Woodrow College Steam Pipe Replacement
University of South Carolina
Project H27-Z338-A

Addendum Three

February 28, 2018

1 SITE PLAN
SCALE: 1" = 20'

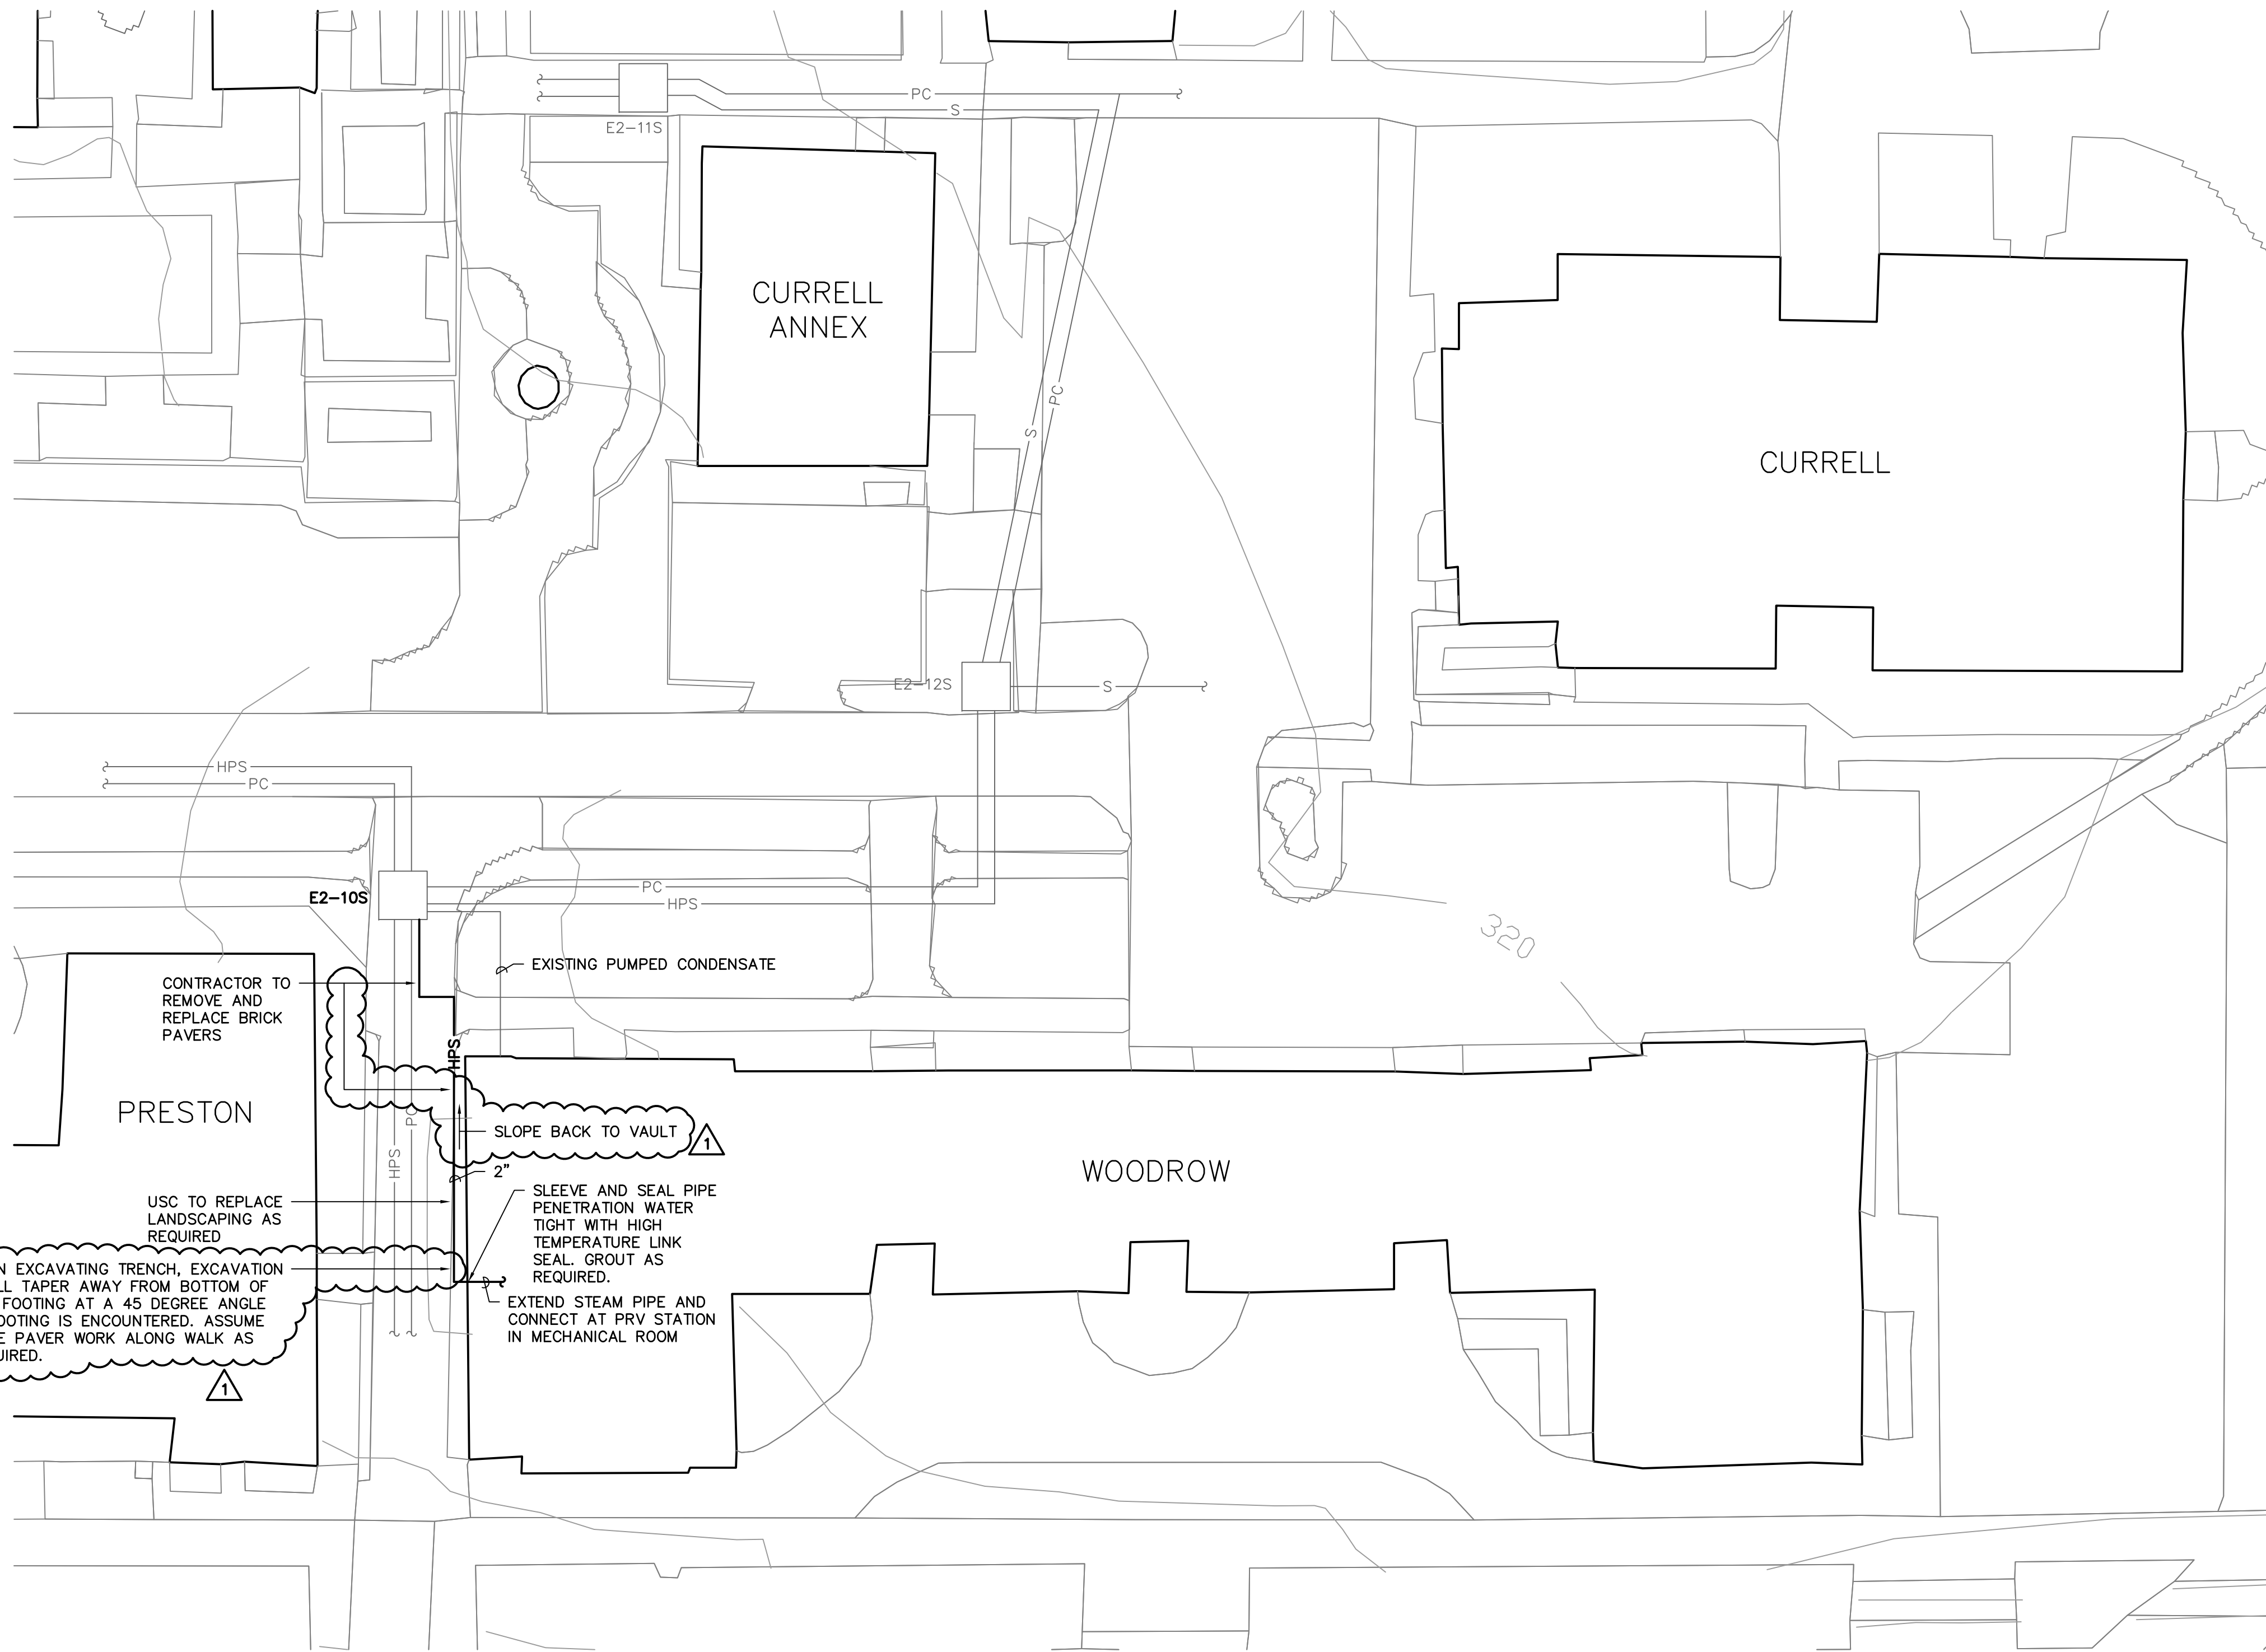
1. Revision: Reference Drawing M1 Site Plan. Revised drawing indicates the pipe routing into the building more clearly and shows the intended slope of the pipe. Also noted is the coordination with the existing footings required if encountered during excavation.
